5 October 2018

Health Infrastructure
C/- TSA Management

**RE: TWEED VALLEY HOSPITAL REDEVELOPMENT -
CONCEPT DEVELOPMENT SSD APPLICATION
ACCESSIBILITY & BUILDING CODE OF AUSTRALIA (BCA) -
(ACCESS TO PREMISES)
COMPLIANCE CAPABILITY REPORT**

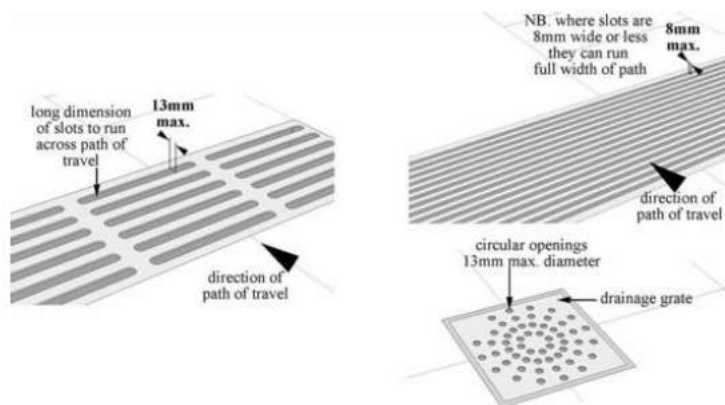
In this regard accessibility for people with disabilities is achievable under the current concept design to comply with BCA and the Access to Premise Standard 2010.

1. Access for people with disabilities is achievable from public road and footpath reserves to comply with the performance requirements of BCA and the design compliance objectives of the Access to Premise Standard which, in essence addresses client obligations under the DDA.
2. The location of the new accessible parking spaces will have direct connection to the principal pedestrian entrances of the related site buildings via accessways that comply with AS1428.1.
3. Lighting will be provided, subject to separate applications, to the accessible parking bays and the paths of travel from the accessible parking bays with 40 lx in accordance with requirements of AS1680.2.1-2008.
4. Grated stormwater drains located on any paths of travel will need to be fitted with compliant heel guard grates.

Grates shall comply with the following:

- (a) Circular openings shall be not greater than 13 mm in diameter.
- (b) Slotted openings shall be not greater than 13 mm wide and be oriented so that the long dimension is transverse to the dominant direction of travel.

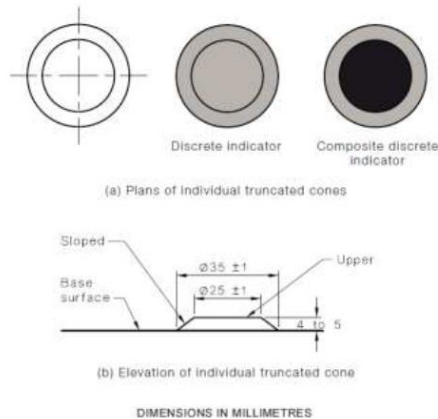
6. The use of TGSIs will be applied to external ramps and stairways only.

TGSIs to warn people of hazards shall comply with AS/NZS 1428.4.1.

The design and arrangement of warning tactile ground surface indicators (TGSIs) shall comply with AS1428.4.1:2009.
